CITY OF SAN MARCOS CONSTRUCTION CHANGE ORDER

PROJECT: Police Department Additions & Renovations
CONTRACT NO.: 220-149

Date Prepared: 07.21.2021
Change Order #: 8

Description: Range -Ballistic containment

SK9A

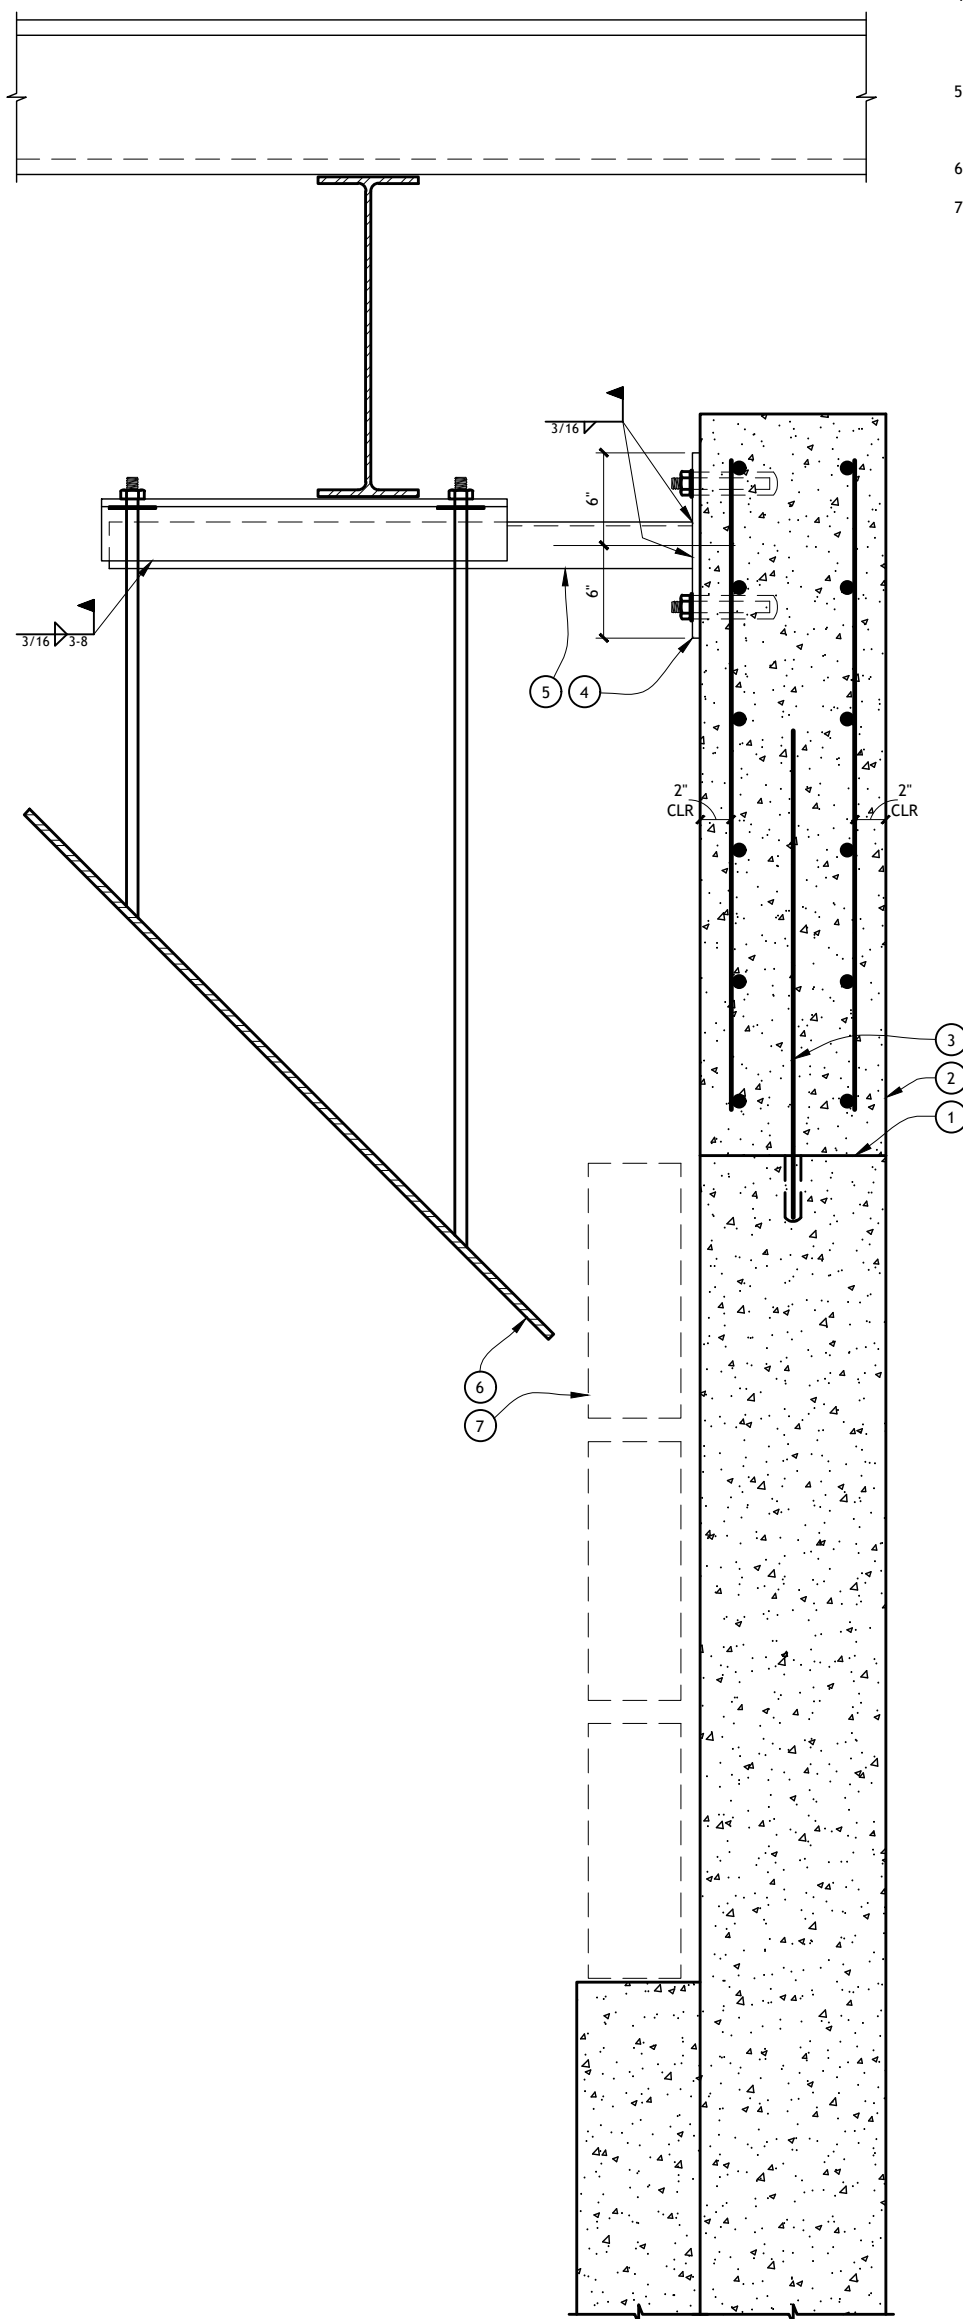
- * Ballistic Containment SMPD - Action Item #11 Per Barker Structural SK9a The only way to build the extension is to remove the steel baffles at grid REa. HR Marc removing one row of rubber blocks and reinstalling in needed areas only.
- * Existing row of ballistic plate will have to be removed. Priced SK9A with weld plates and anchoring plates no difference in price. Forklift will be required for removal and installation of existing ballistic plates, Priced with Trimbuilt providing forklift for use.

Trimbuilt Notes-
 Ballistic Containment
 SMPD - Action Item #11
 Per Barker Structural SK9a
 The only way to build the extension is to remove the steel baffles at grid REa.

Remove back row of ballistic plate and reinstall after work for SK9A has been finished.
Remove/Reinstall ballistic plate = \$4800.00

Fabricate base plate, 3x3x1/4 angle iron and weld to existing 4x4 angle iron per details of drawing SK9A.

NOTE: Existing row of ballistic plate will have to be removed. Priced SK9A with weld plates and anchoring plates no difference in price. Forklift will be required for removal and installation of existing ballistic plates, Priced with Trimbuilt providing forklift for use. Pricing excludes all concrete, grout and coating on steel. Shop Drawings are not included in pricing.

1. CONCRETE WALL.
2. NEW 12" CONCRETE WALL WITH #6 VERTS AT 14" O.C. EACH FACE AND #4 HORIZONTALS AT 16" O.C. EACH FACE. SLOPE TOP OF WALL PER ARCH'L.
3. #5 DOWEL WITH HILTI HY-200 EPOXY AT 24" O.C. EMBEDDED 4" MINIMUM PER ESR-3187.
4. 1/4x1'-0"x0'-4" STEEL PLATE WITH (2) 3/4"Ø HILTI HY-200 EPOXY ANCHORS AT 8" O.C. EMBEDDED 4" MINIMUM PER ESR-3187.
5. STEEL ANGLE - 3x3x1/4 LAPPED WITH EACH EXISTING HORIZONTAL STEEL ANGLE.
6. LINE OF STEEL BAFFLE - SEE ARCH'L.
7. LINE OF BALLISTIC RUBBER BLOCKS - SEE ARCH'L.
